**Bartlett Regional Hospital Emergency Department Ventilation Upgrades
Contract No. BE22-037**

ADDENDUM NO.: TWO

DATE ADDENDUM ISSUED: July 29, 2021

Trauma and Storage Room Reference Photos

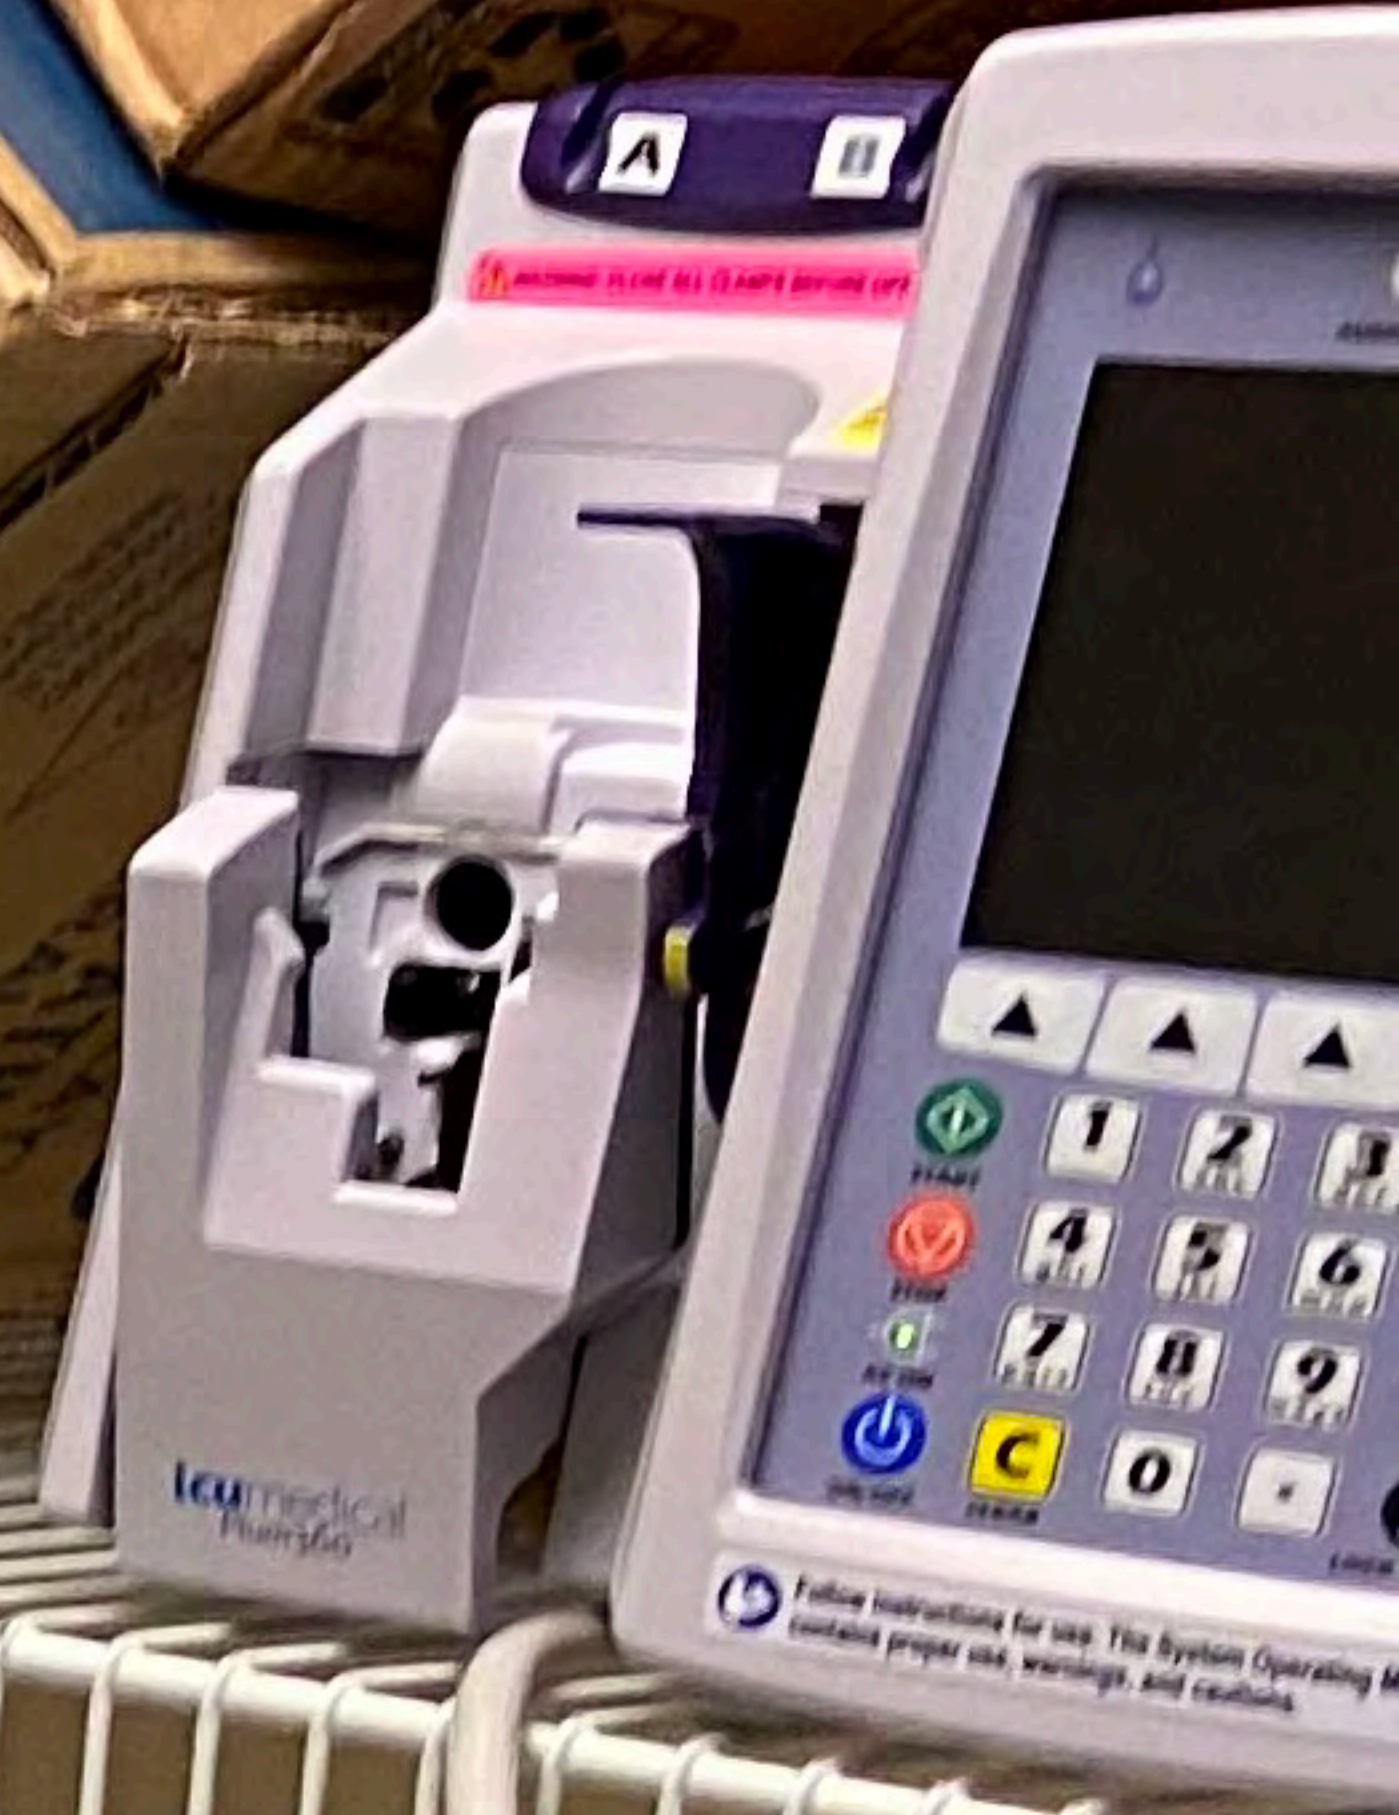
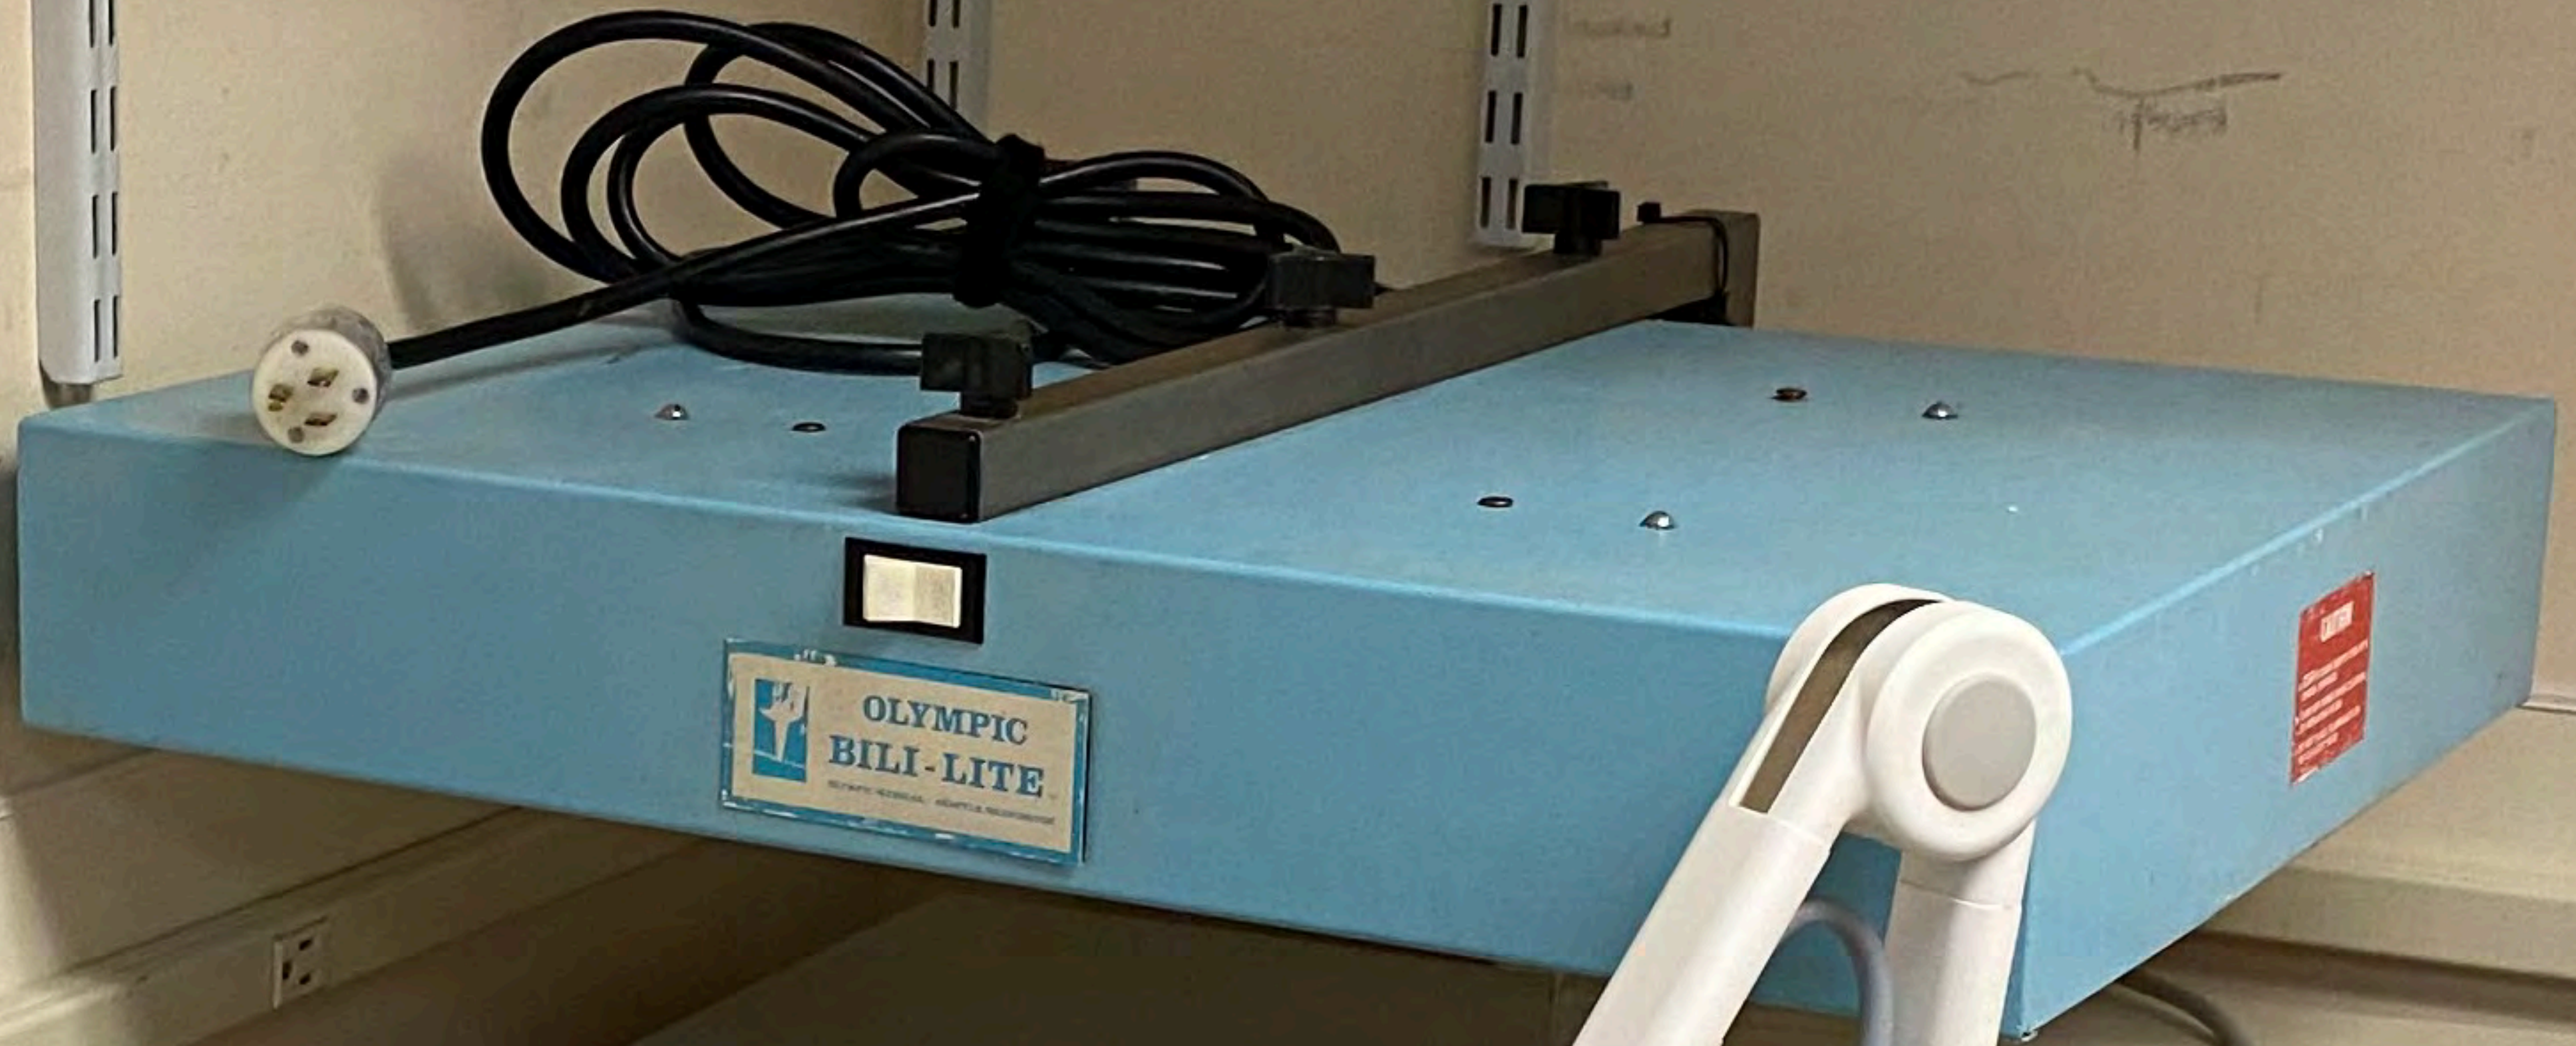
- Item No. 2 Attached are informational photos of the existing receptacle raceway to be removed and replaced in Room 2748 as necessary to allow for new mechanical duct work and chase and as shown on Sheet E202.

A-403

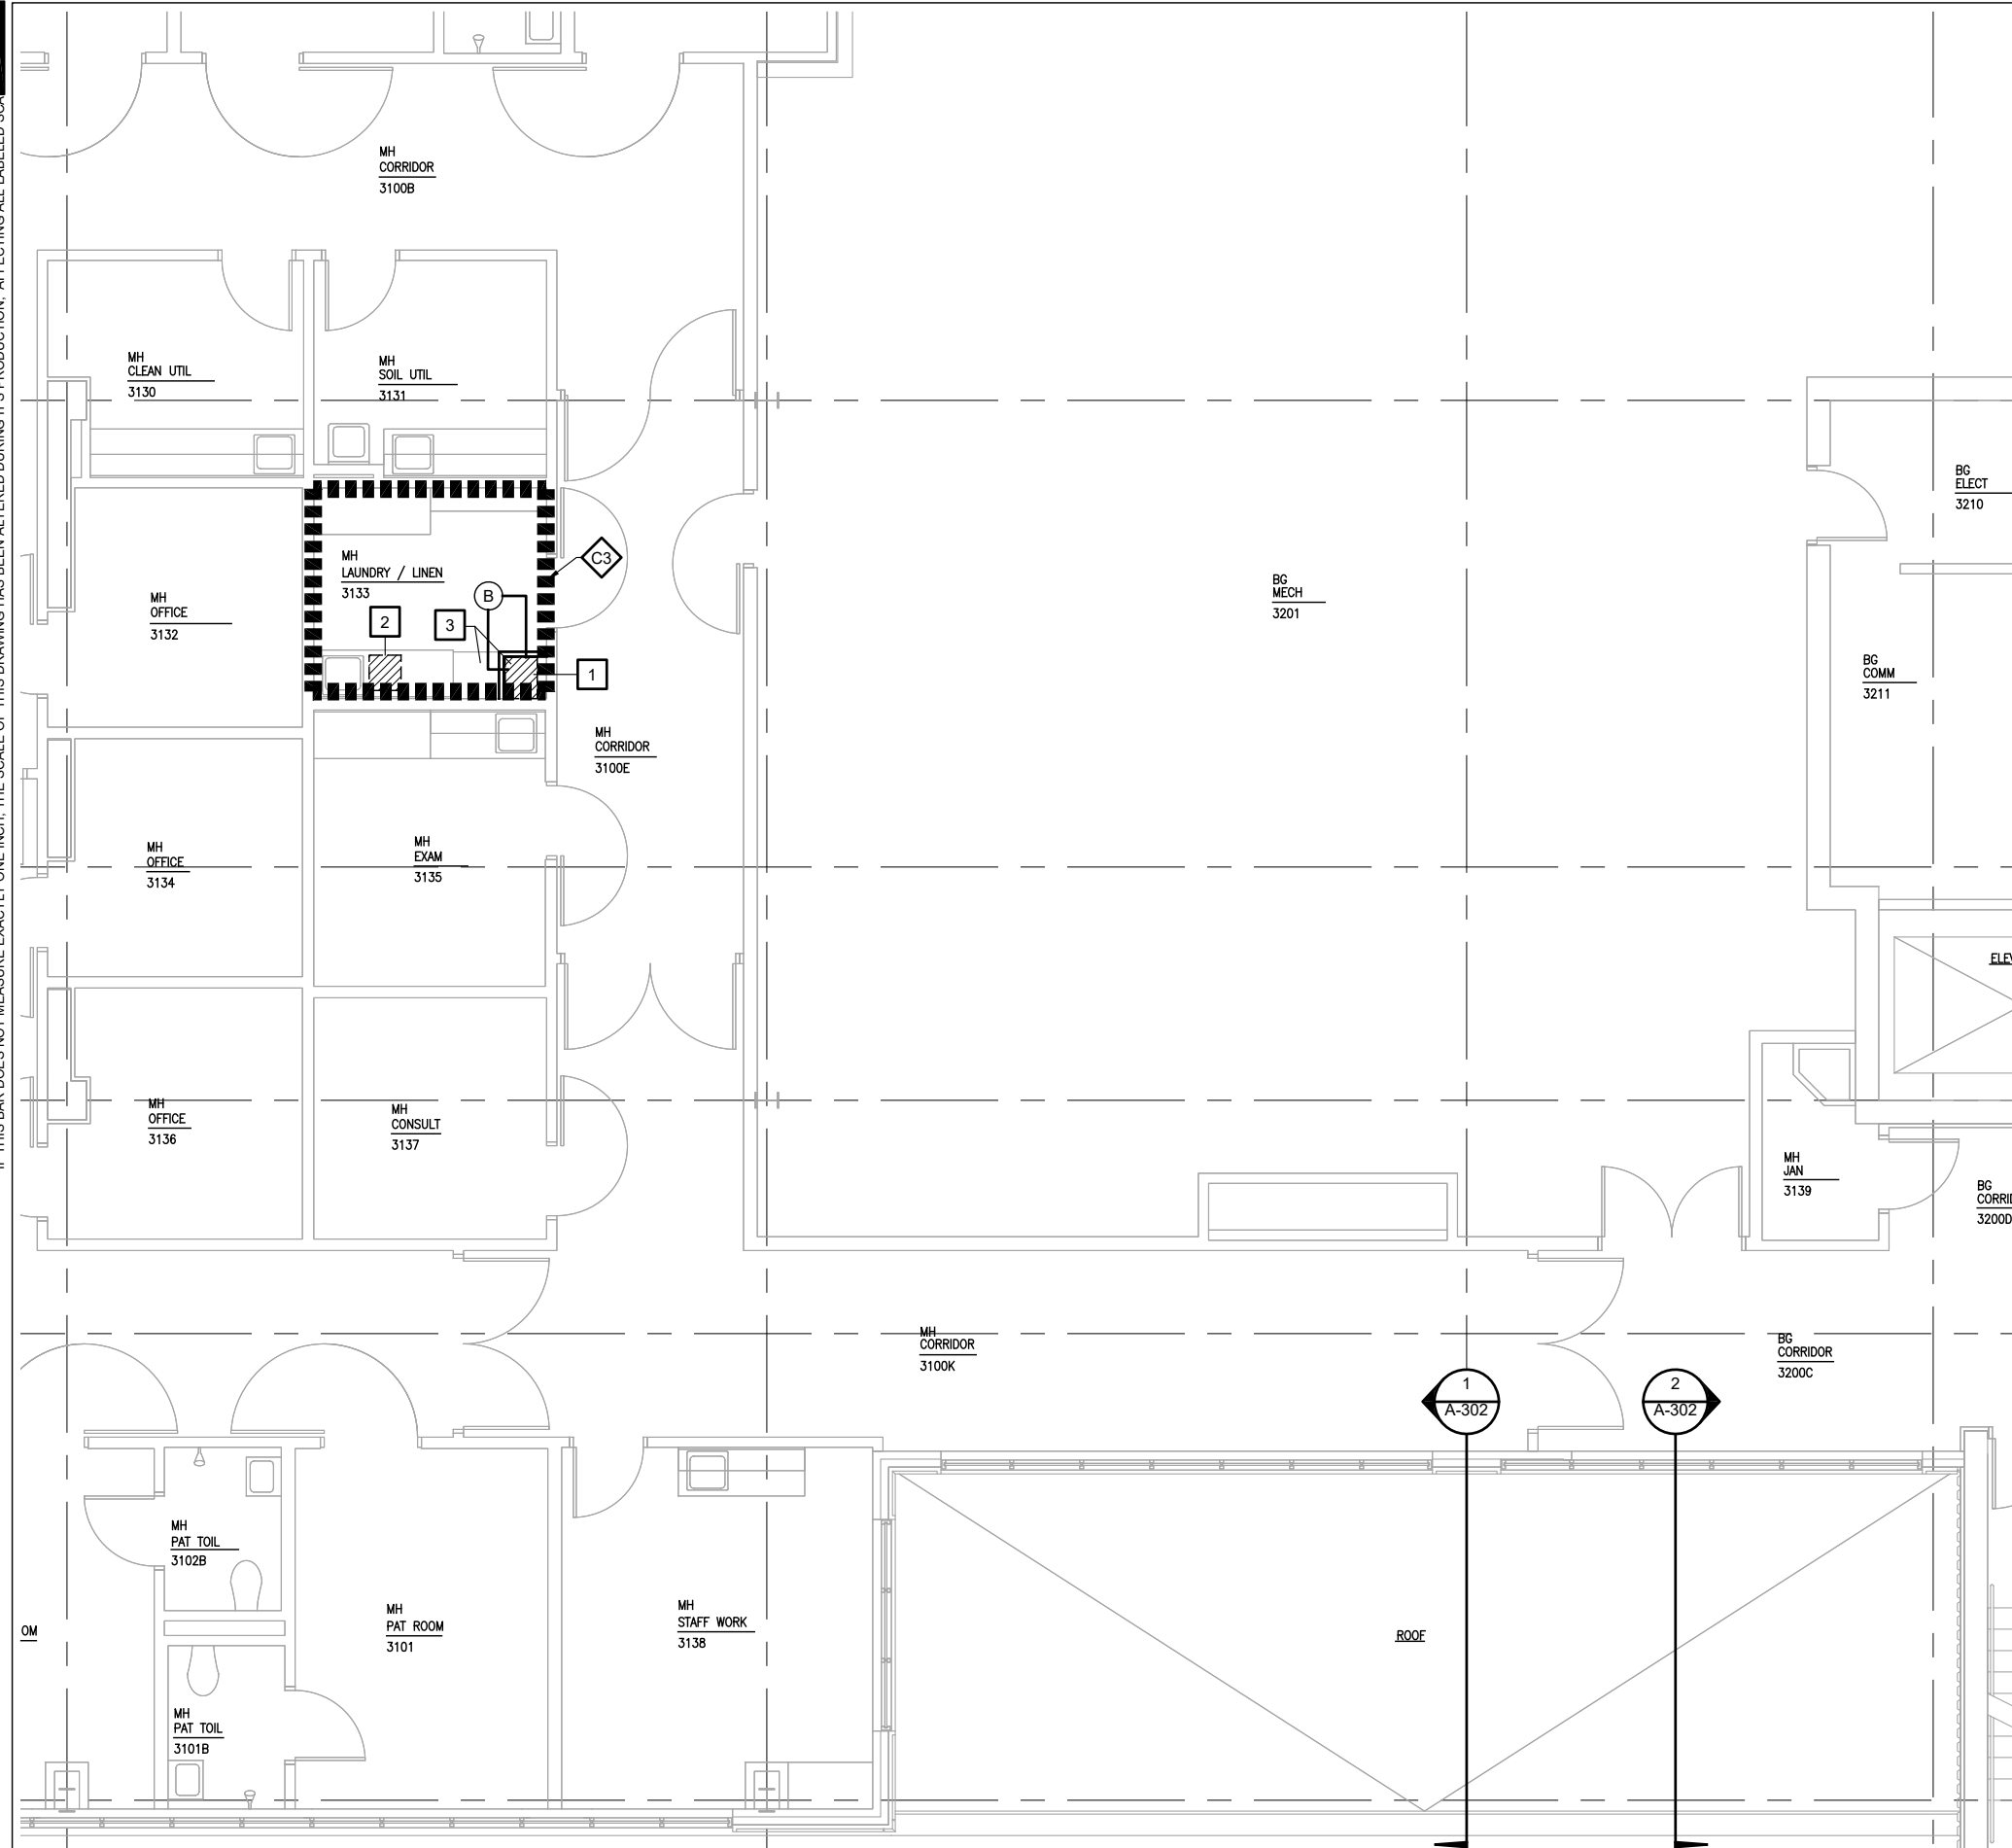
Item No. 13 PLAN SHEET A-403, SHEET KEY NOTES, KEY NOTE 2, **add** the following:
"COORDINATE CONCRETE FLOOR PENETRATIONS WITH EXISTING IN-SLAB ELECTRICAL CONDUITS AND OTHER UTILITIES TO AVOID DAMAGING ANY IN-SLAB ELECTRICAL OR OTHER UTILITIES. CONTRACTOR IS RESPONSIBLE FOR DAMAGE AND REPAIRS TO ANY INSLAB UTILITIES."

- 2 SAW CUT OR CORE CONC ROOF ASSEMBLY ABOVE FOR MECH WORK, PATCH CONC SLAB AS REQ, REMOVE ROOFING ASSEMBLY ABOVE CONCRETE DECK AS REQ COORDINATE CONCRETE FLOOR PENETRATIONS AND SIZE FOR EXHAUST DUCTS WITH EXISTING INSLAB REINFORCEMENT TO AVOID CUTTING REINFORCEMENT BARS, SEAL DUCT PENETRATIONS AT 2HR FLOOR FOLLOWING HILTI C-AJ-7084 WITH FS-ONE MAX AND MINERAL WOOL PACKING MATERIAL, COORDINATE CONCRETE FLOOR PENETRATIONS WITH EXISTING IN-SLAB ELECTRICAL CONDUITS AND OTHER UTILITIES TO AVOID DAMAGING ANY IN-SLAB ELECTRICAL OR OTHER UTILITIES. CONTRACTOR IS RESPONSIBLE FOR DAMAGE AND REPAIRS TO ANY INSLAB UTILITIES
